**From:** Martina Mackin  
**Sent:** 22 February 2021 11:11  
**To:** Nick Wright  
**Subject:** RE: -21/00101/FUL

In response to your letter dated 19th February 2021 I attach revised drawing set to address the matters that have been raised.

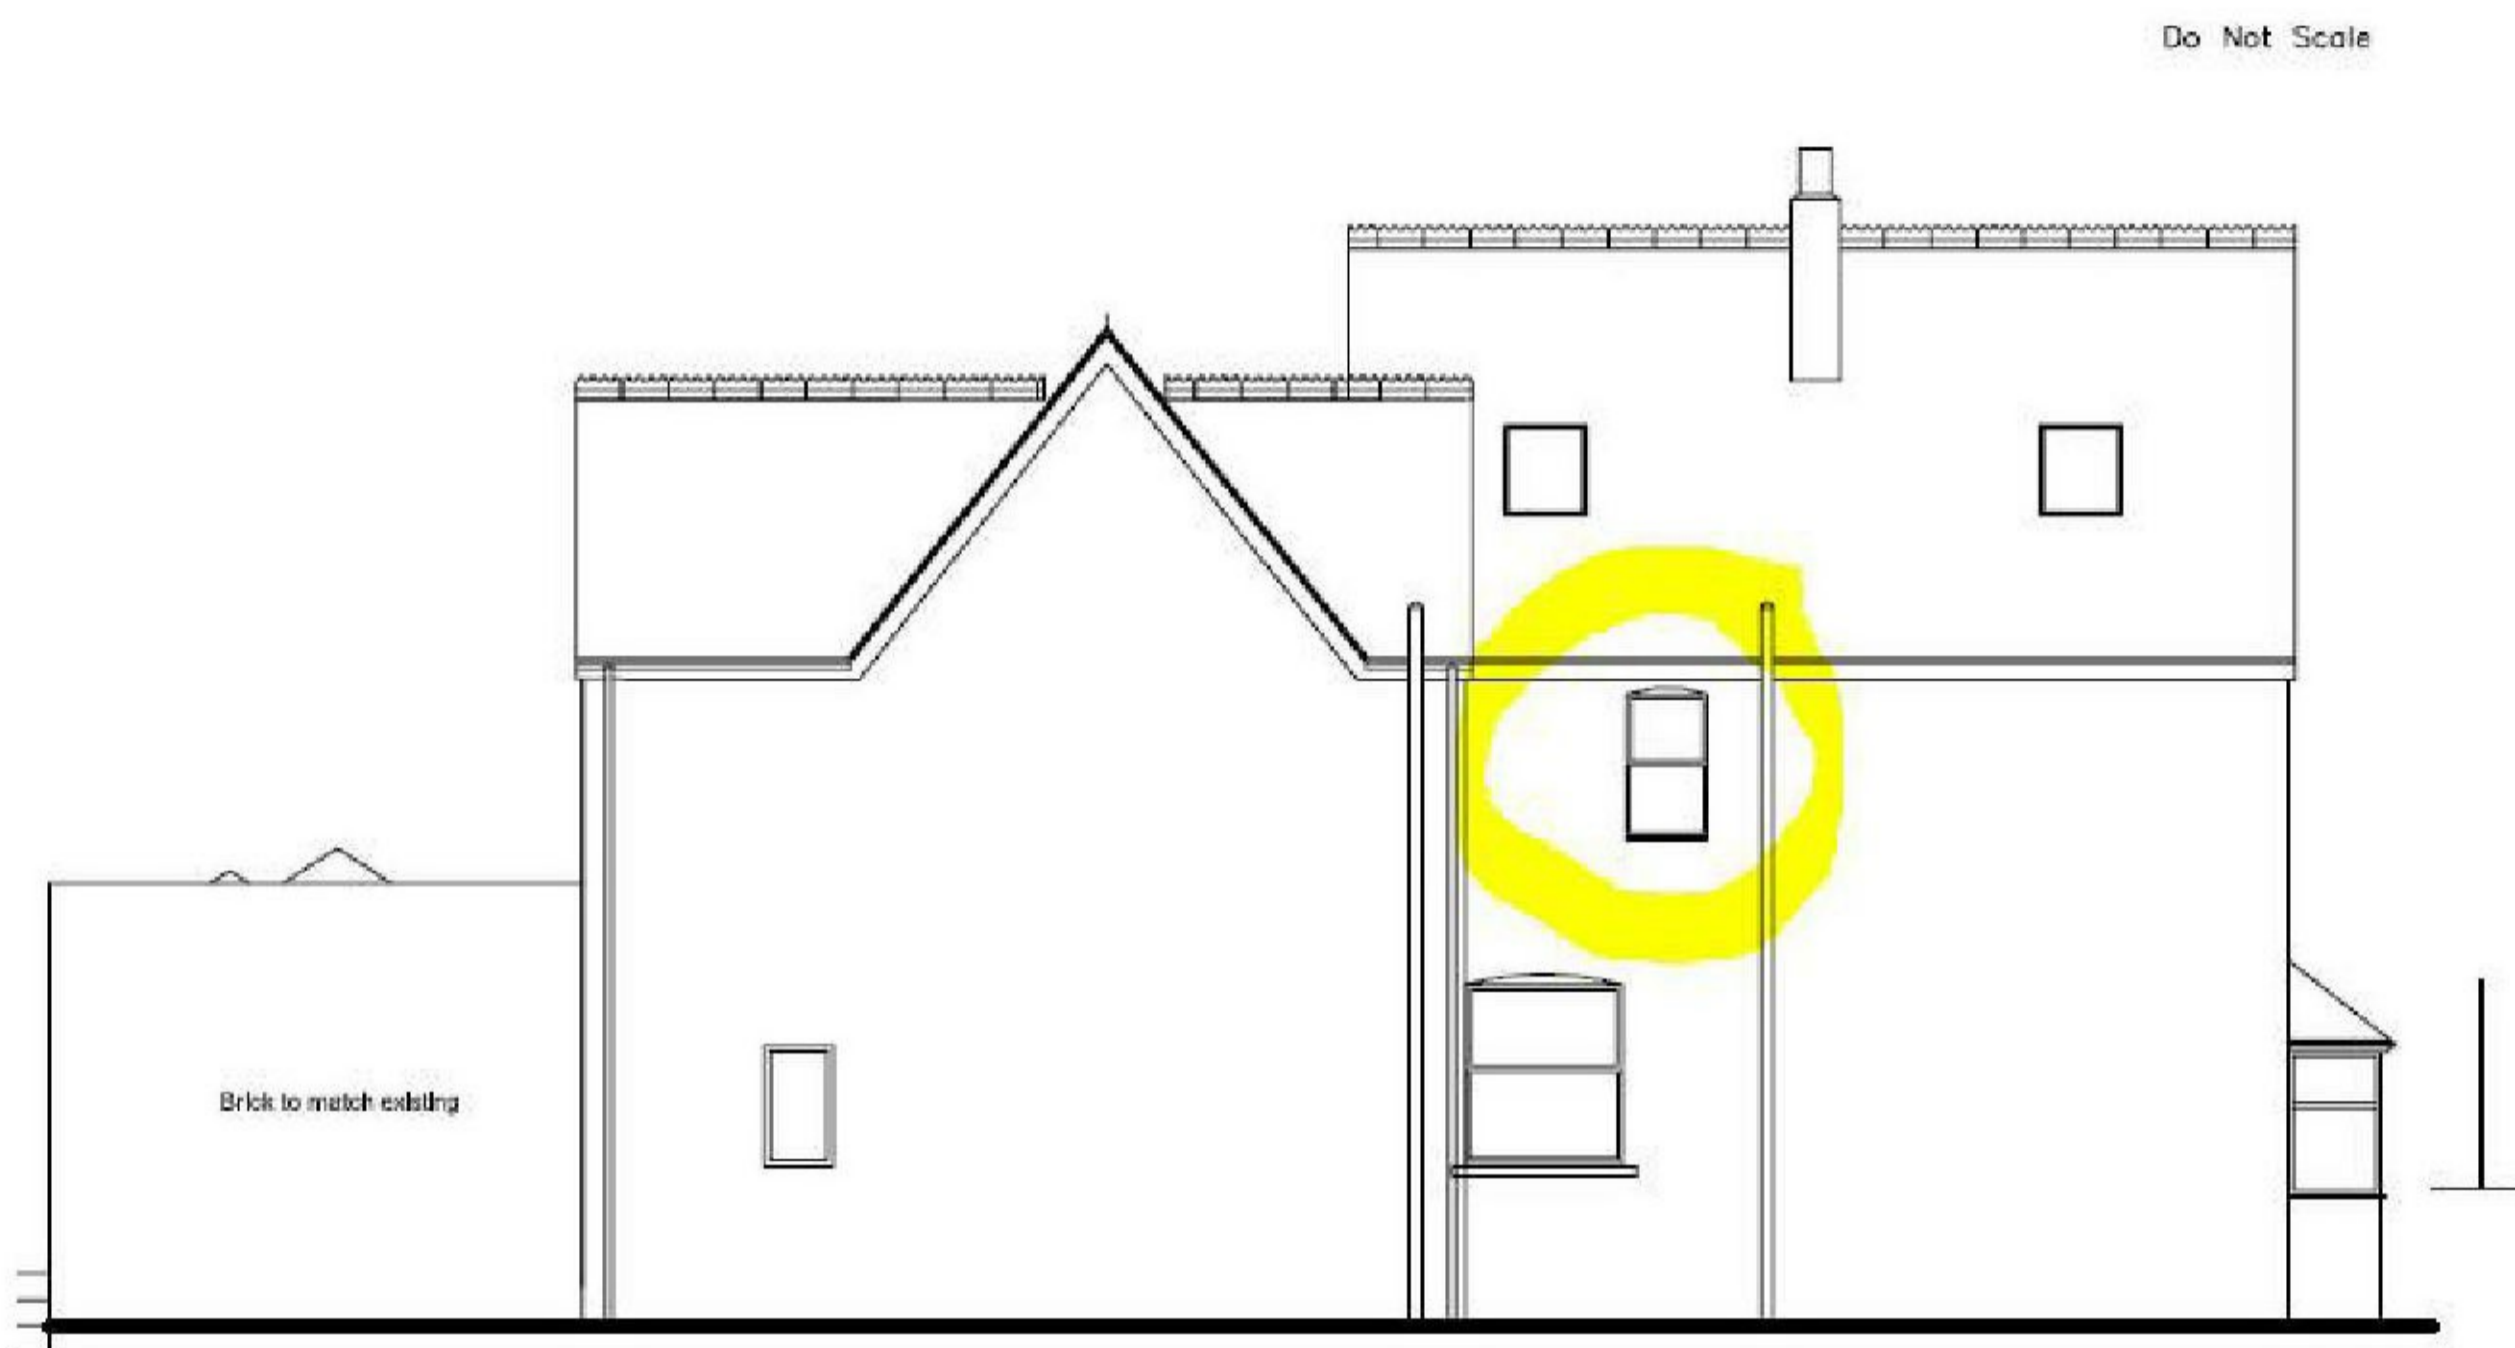
One more issue that still seems to be present is the window shown below, it does not appear to be shown on the existing or proposed floor plans but it is present on both elevational plans.
